City of Ryde Local Planning Panel Meeting No. 6/20

**City of Ryde
Local Planning Panel Report**

DA Number	LDA2019/0411
Site Address & Ward	38 Wicks Road, North Ryde East Ward
Zoning	R2 Low Density Residential
Proposal	Torrens Title subdivision to create two lots and construction of a dwelling house on each resulting lot
Property Owners	Sang Min Lee
Applicant	Hall & Hard Homes Pty Ltd
Report Author	Ben Tesoriero Consultant Planner
Lodgement Date	22 November 2019
No. of Submissions	One (1) submission objecting to the development
Cost of Works	\$1,209,756.50
Reason for Referral to LPP	Departure from Development Standard –The proposal results in a 22.3% departure from the minimum subdivision lot size standard prescribed under cl.4.1(3) of RLEP 2014.
Recommendation	Approval (Deferred Commencement)
Attachments	1. Compliance Table Ryde LEP and DCP 2. Draft conditions of consent

Figure 10 – The north-western corner of the dwelling which is elevated.

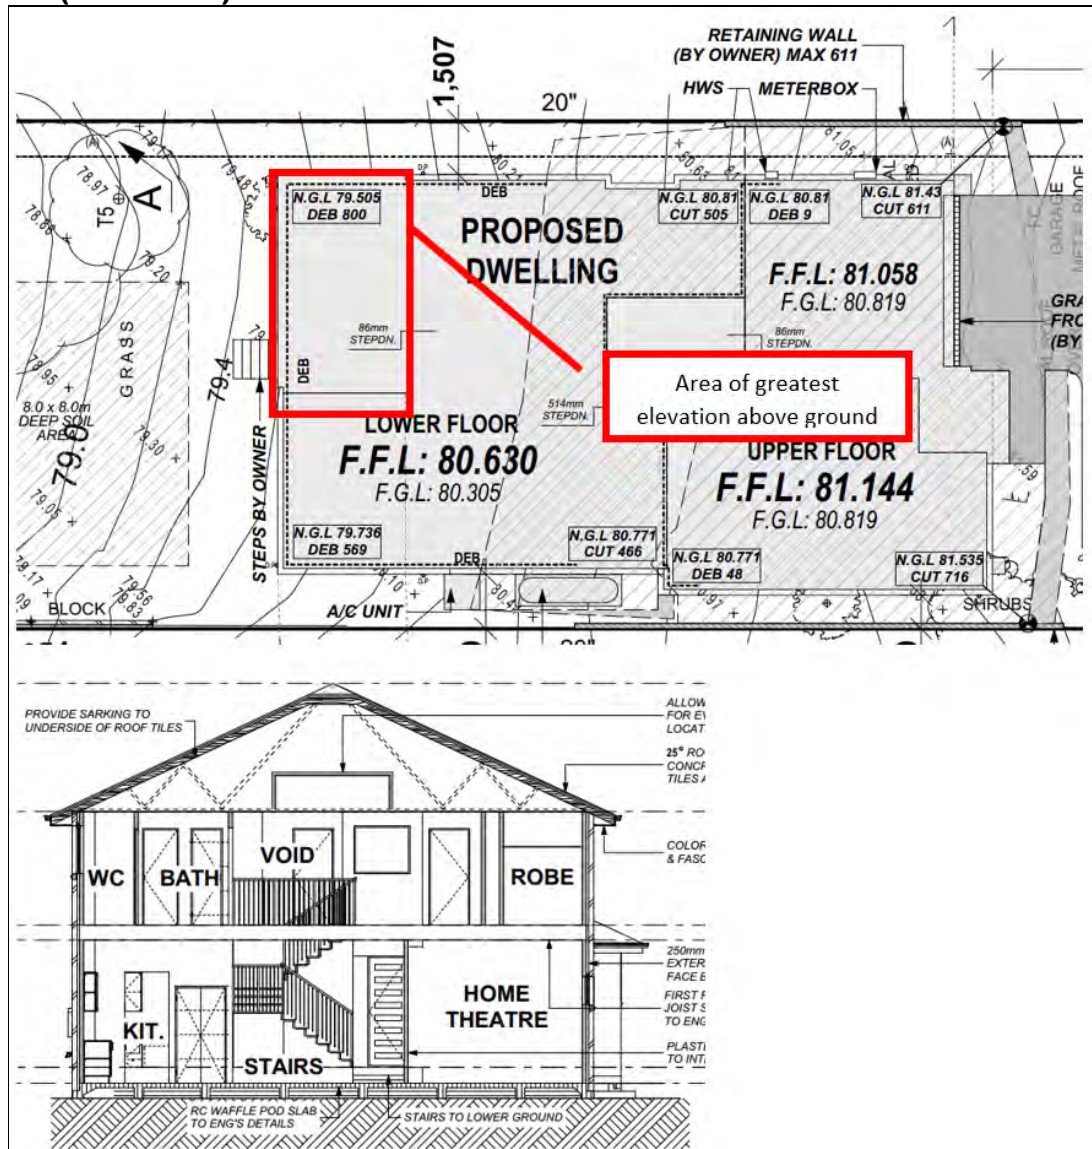
The proposal would technically comply with cut and filling requirements, as the levels of excavation and filling (both within and outside the proposed building footprints) would be within RDCP 2014 requirements. The plans however indicate that both dwellings would be placed on 'waffle-pod' slabs, and that the north eastern rear

corner of the dwelling on Lot 2 (alfresco area) would be significantly elevated 1140mm above ground level (**Figure 10**). Whilst the area under the rear of this dwelling would not technically be 'filled', it would present the appearance of a structure that is built above natural ground level and the existing landform of the site.

Figure 11 – The proposed side setback of 950mm from south-western side boundary
Source: Hart & Home 2020

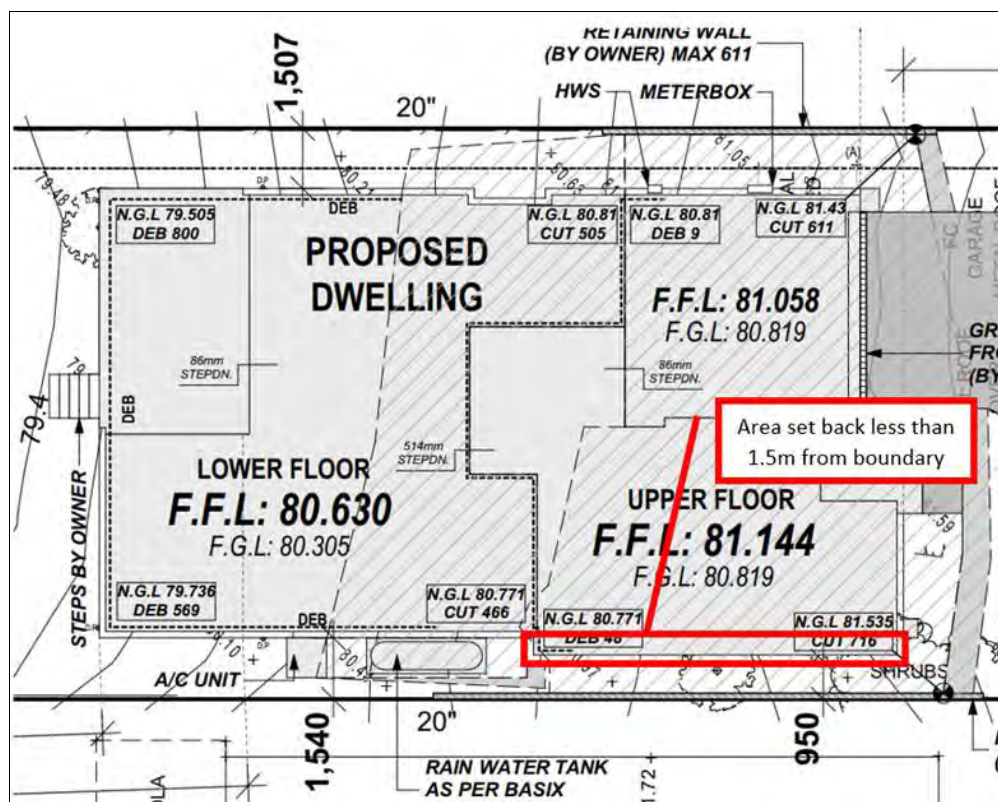
Control (b) requires 1.5 metre side setbacks for two storey dwellings. The proposed dwelling on Lot 1 is compliant with this requirement. However, the proposed dwelling on Lot 2 is set back 950mm from the south western side boundary (Figure 11) and does not comply. The proposal is considered acceptable for the following reasons:

- The extent of non-compliance along the south western elevation is for a length of 7.38 metres. The remainder of the elevation provides for a 1.504 metre setback and complies.
- The non compliance occurs at ground floor with the first floor complying with the required setback.
- The rear of the dwelling where it is elevated achieves a compliant side setback.
- The elevation contains a single window associated with the ensuite and does not result in any adverse privacy impact upon the adjoining dwelling at 36A Wicks Road.
- The non compliant setback does not result in any unacceptable overshadowing to the adjoining dwelling.

On this basis, the minor variation is acceptable.

Figure 13 Tree 3 and 4 proposed for removal Source: Hart & Home 2020

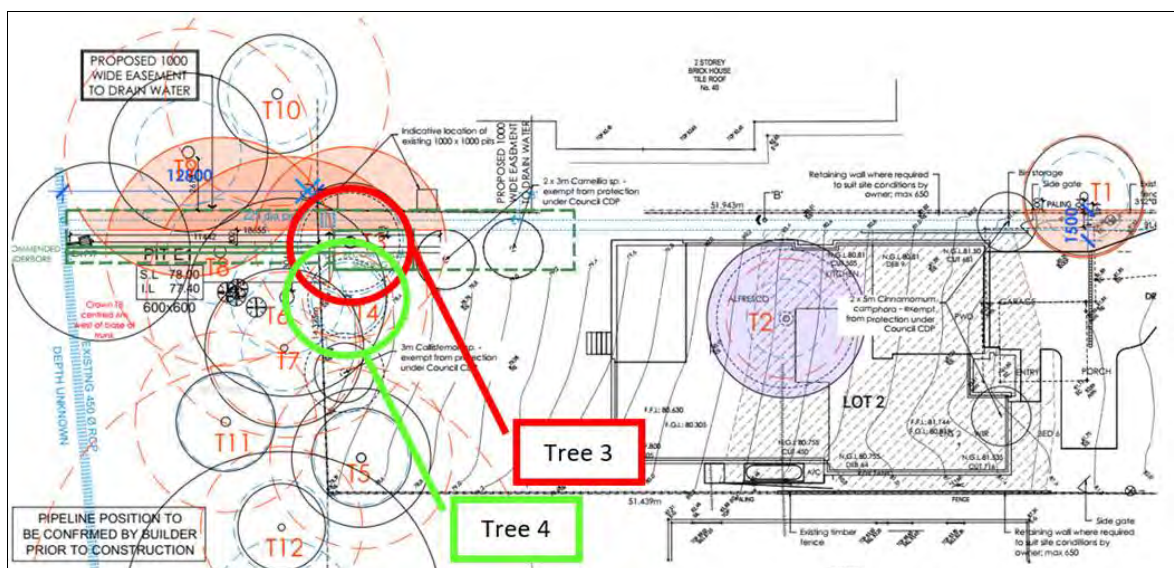
The proposal also includes the removal of Tree 2 (Gordonia) which is sited within the building footprint of Lot 2. The submitted landscape plan additionally shows the removal of Tree 3 and 4 (Chinese Weeping Cypress and Ash Tree) (**Figure 13**). The proposed removal is necessary to accommodate the proposed underbore stormwater pipe to the North Ryde Golf Course. Compensatory tree planting or two local Australian native trees with a minimum pot size of 45 litres has been recommended by way of consent conditions.
